SR 360 WIDENING
CSSTP-0006-00(049) - P.I. No. 0006049
Cobb and Paulding Counties, Georgia

Value Engineering Study Report
Preliminary Design Stage

re: Project No. CSSTP-0006-00(049), P.I. #0006049
Widening of SR 120/Charles Hardy Parkway to SR 176/Lost Mountain Road
Value Engineering Study Report

ALTERNATIVE NO.
P-7
SHEET 2 OF 7

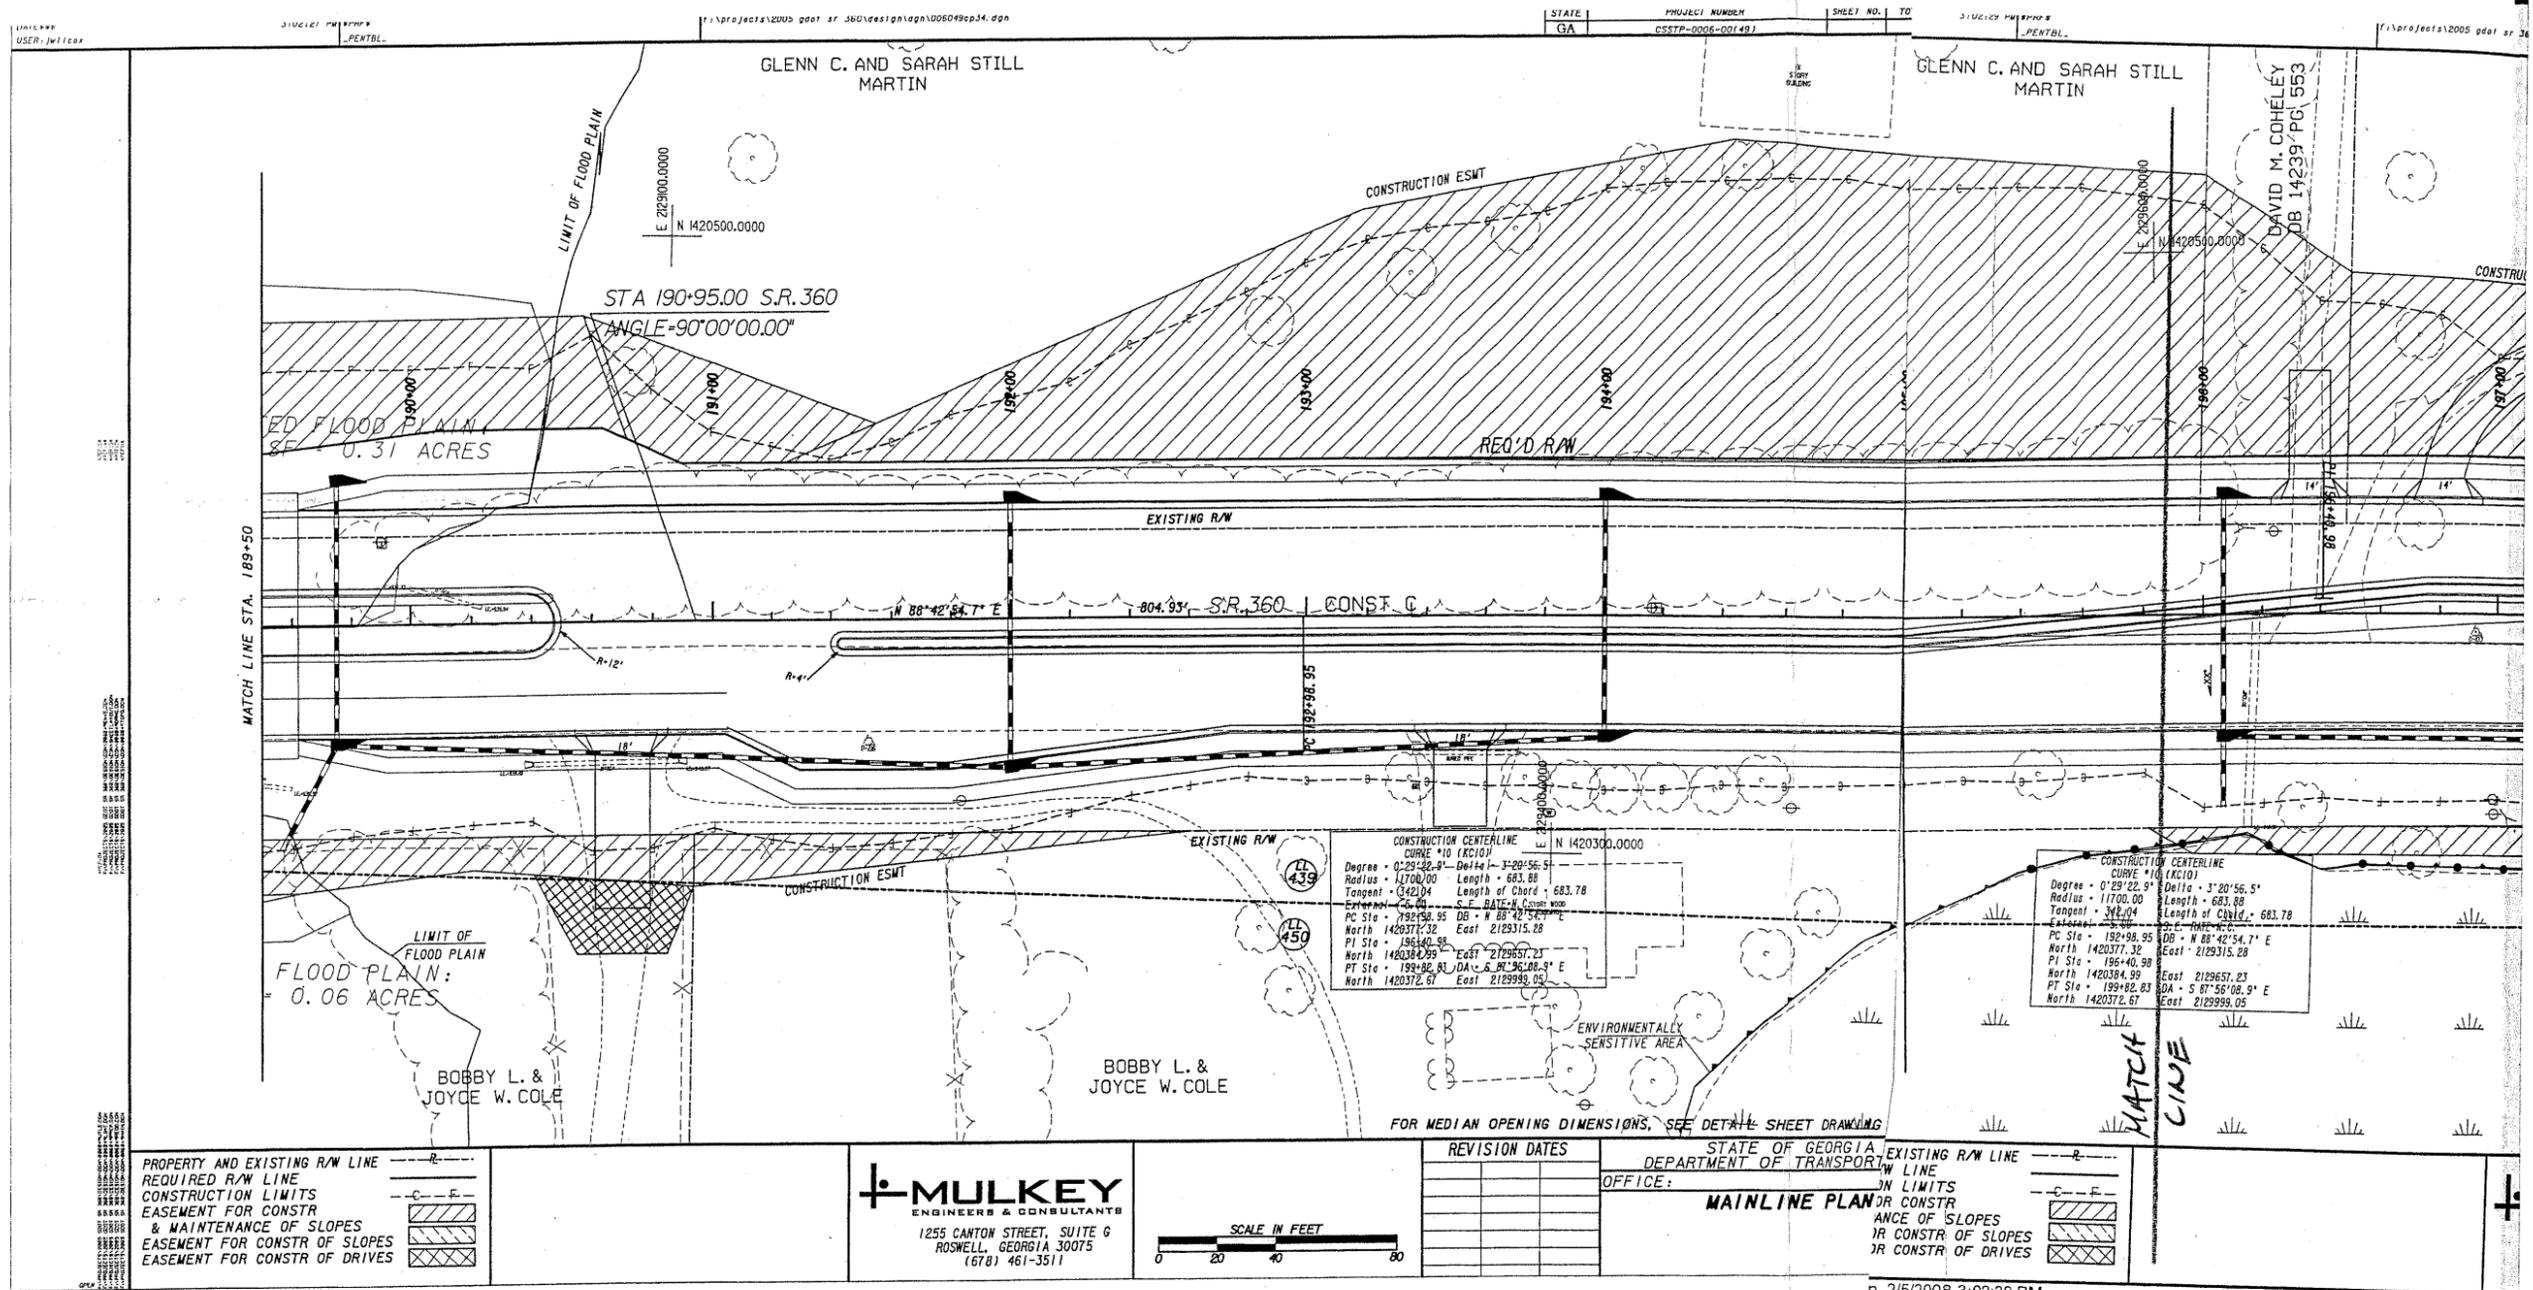
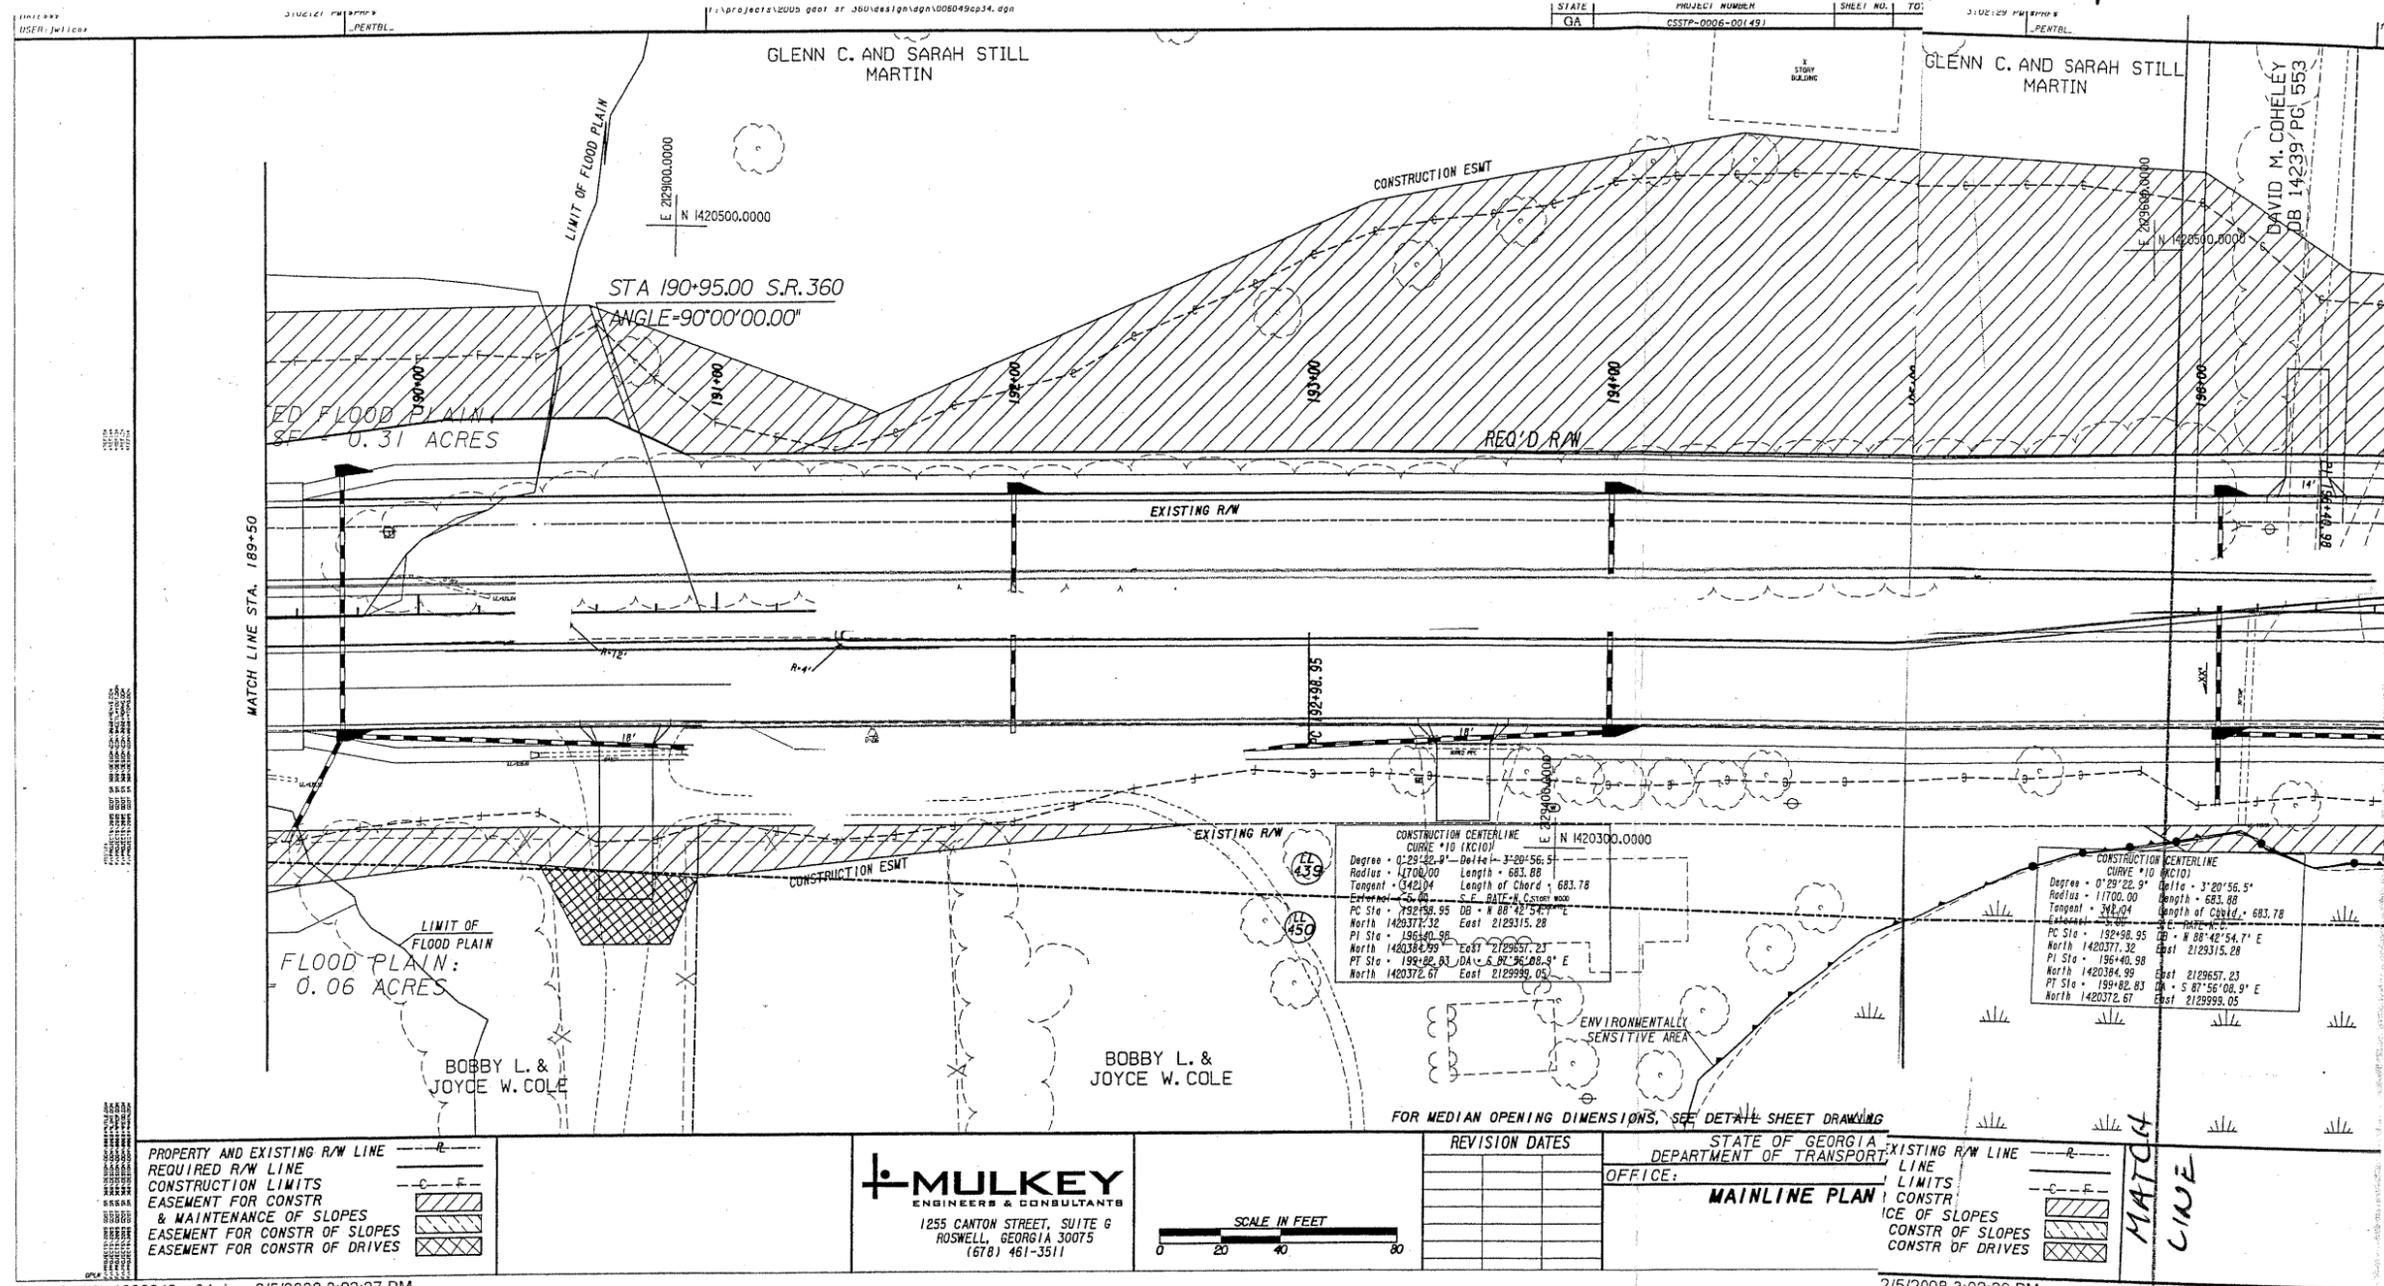
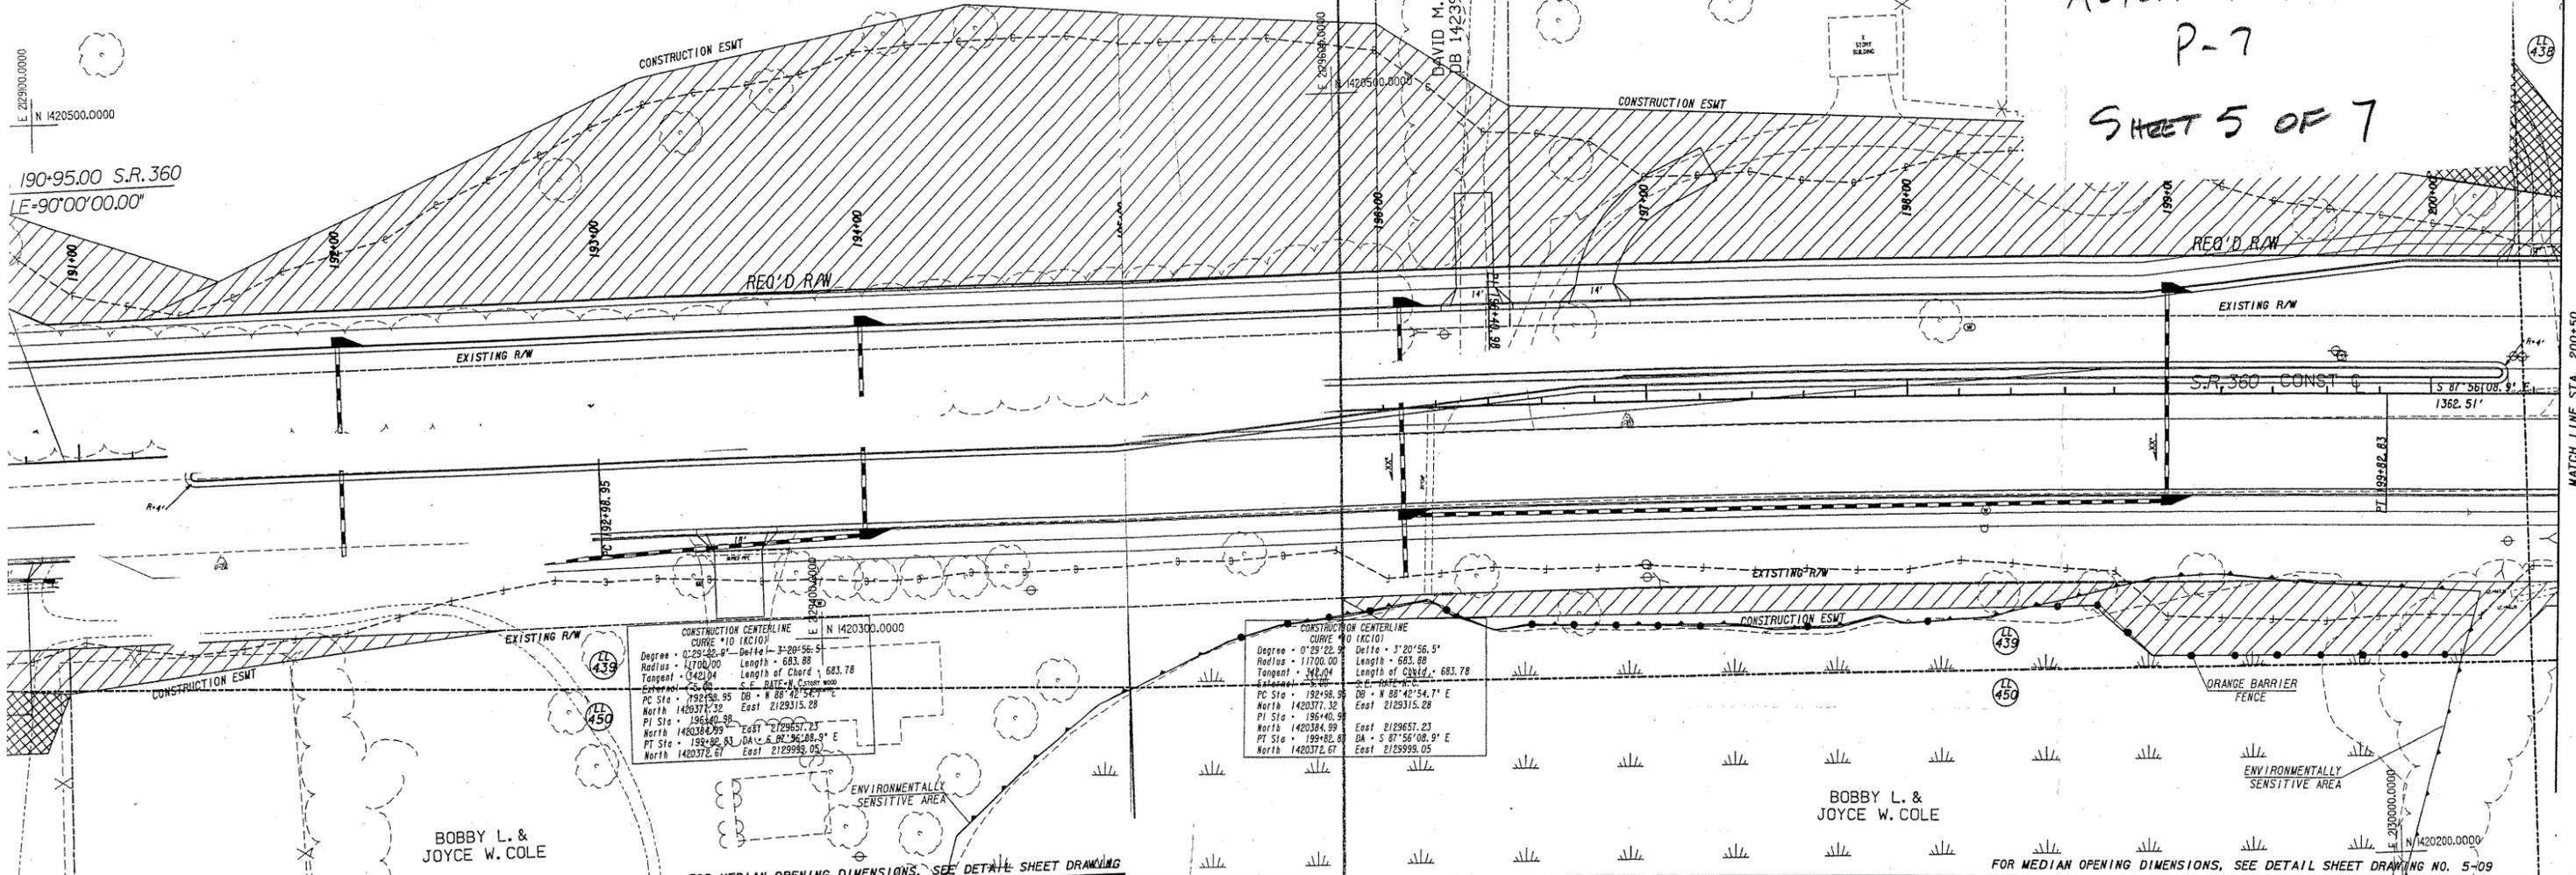
DESCRIPTION: **REMOVE U-TURN AT STATION 191+00**

Delete the U-turn at Station 191+00.
